TAB PUNCHLIST - CFA 05535 08/27/24

L05535_South Topeka Blvd (KS) FSU

3231 Southwest Topeka Boulevard, Topeka, Kansas

#189 [UNIT 999] [NEW] (MISC) P/P1 not connected to economizer module on AC4

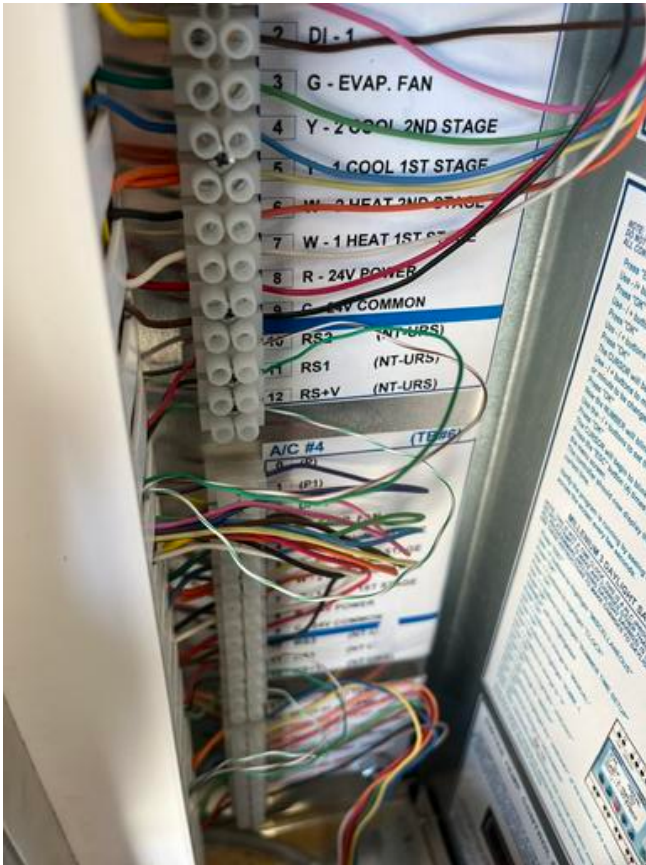
Description
On AC4, P/P1 from the Suncoast panel should connect to P/P1 on the economizer module inside the unit.

Sheet
M-502

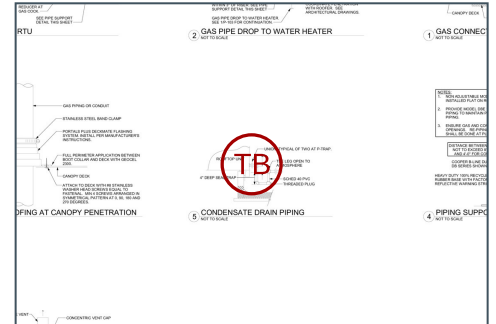
Equipment condensate piping or p-trap is not constructed per normal CFA specifications.
